**ZONING ADMINISTRATOR'S REPORT
VARIANCE APPLICATION
5201 Perfect Drive**

Owner: Dennis Tiziani / Cherokee Property Development LLC

Project Description: Requests a variance to the attached garage setback requirement to construct a new single-family dwelling.

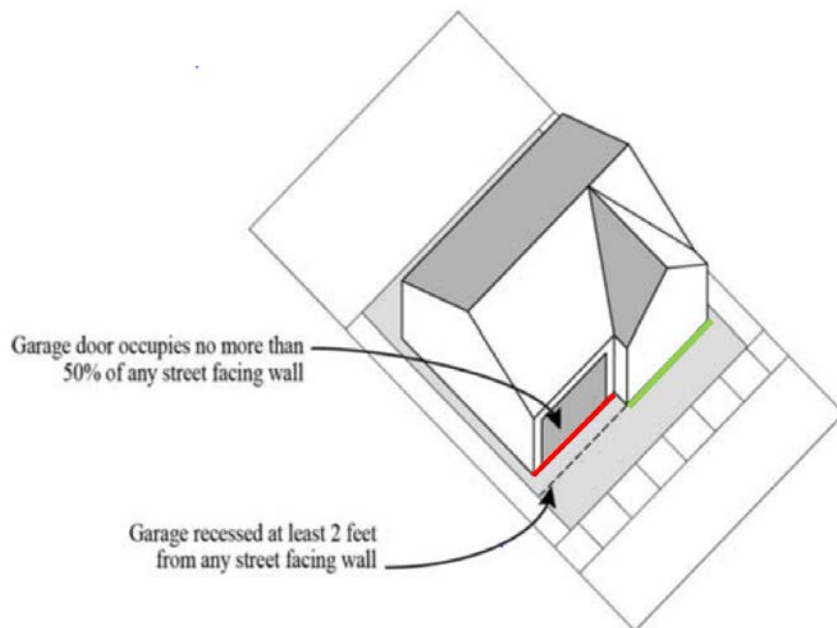
Requested variance: The Garage wall with garage door (red) facing the street Perfect Drive is forward of the remainder of the facade (green).

In this case, the subject property abuts a public right-of-way to the south and west. Either the west or south-facing façade will have a wall with a garage door facing a street, given the lot fronts on two streets. Because the lot is a corner lot, the view of the home is not limited only to the garage wall and door. Generally, the home has an attractive presence as viewed from the adjacent streets.

3. Aspects of the request making compliance with the zoning code burdensome: The lot does allow for a code-compliant garage wall/door orientation, however, the wall/door and driveway placement creates direct vehicle conflicts with the commercial driveway immediately across Perfect Drive that serves the Cherokee Country Club and Golf Course.

Other Comments: The primary reason for this request is vehicle safety for both the occupants of the home who will back out of their garage/driveway and vehicles entering and leaving the country club property. The compliant garage placement will necessitate a vehicle backing down the sloped driveway, while turning, to Perfect Drive. Per a discussion with Eric Halvorson from City Traffic Engineering, he indicates the preferred alignment for the driveway is as requested by the variance, which would limit potential commercial driveway vehicle conflicts on Perfect Drive.

Staff Recommendation: It appears standards have been met, therefore staff recommends **approval** of the variance request, subject to further testimony and new information provided during the public hearing.
